Road Safety Audit Review

Pond Road

Town of Hinesburg

Pond Road Road Safety Audit Review Review Report

Curve near 975 Pond Road

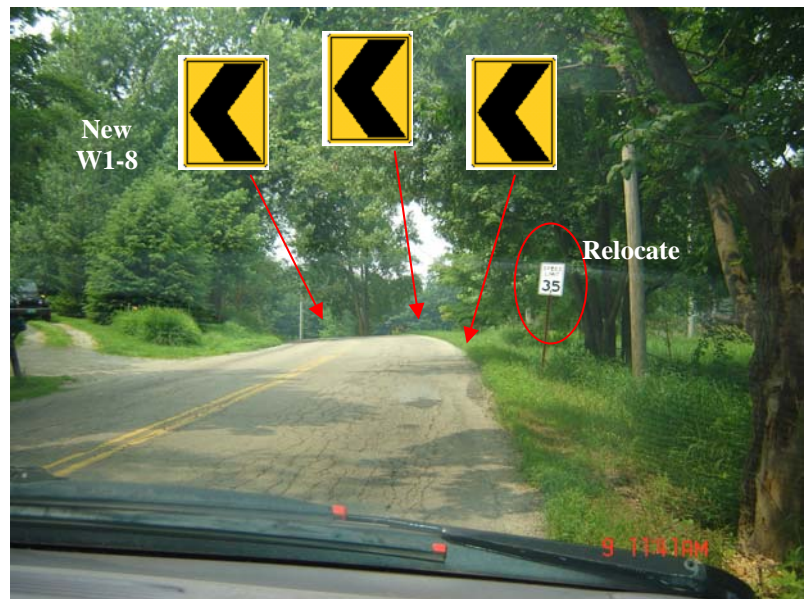
SW, add a new 30" x 30" curve sign (W1-2 L)

Relocate (replace with new 24" x 30", type III R2-1) the speed limit sign to 120 ft west of mail box 1081

Add 24" x 30" chevrons (W1-8) 120 ft apart

NE, Replace the Hidden Drive with a new 30" x 30" Hidden Drive Right (VW-054)

Curve near Place Road

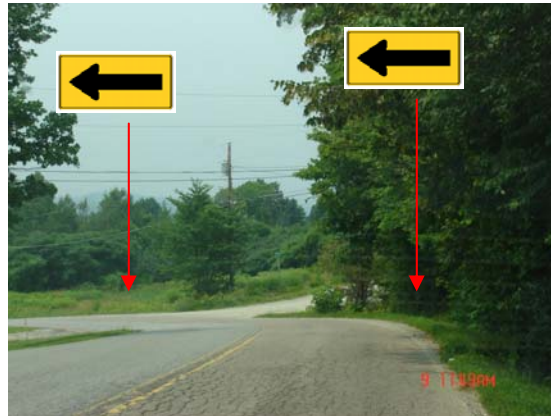
SW, replace the curve sign with a new 30" x 30" curve/side road sign (W1-10 L)

Replace the advisory plaque with a new 21" x 21" advisory speed plaque (W13-1)

Add a 48" x 24" arrow (W1-6) on two posts before and after Place Road

Corner sight distance to the right on Aube Ridge is slightly obstructed

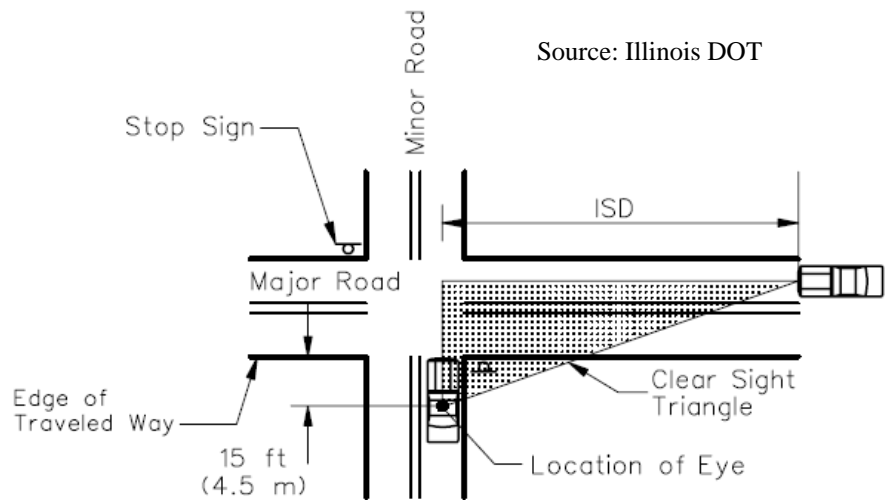
Remove obstruction outside of the corner

Promote a clear sight triangle as recommended by AASHTO

From the edge of the road, measure 15 ft back (this is the vertex of the sight triangle)

For an estimated traveling speed of 40 mph, "ISD" is 390 ft

Anything within the triangle area such defined should be as much as possible removed

Severe edge drop-offs could cause motorists to lose control

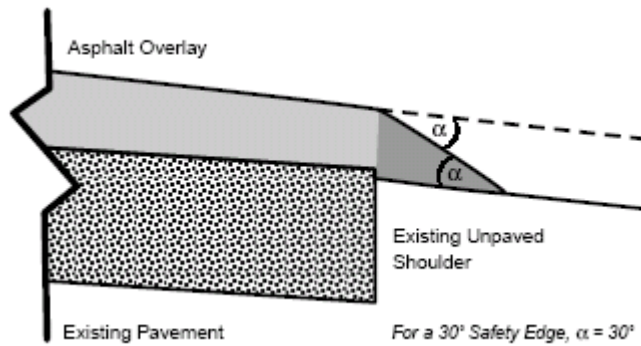
Review the locations where edge drop-offs exist

The edge drop that is being created could cause a motorist that went of the road to lose control when trying to get back on the pavement

Drop-offs of three or more inches are unsafe if the roadway edge is at a 90-degree angle to the shoulder surface

Consider specifying a 30-35 degree angle asphalt fillet (called the "Safety Edge" by FHWA) in the contract specification of the next paving project for this road

Pull up the shoulder area where applicable
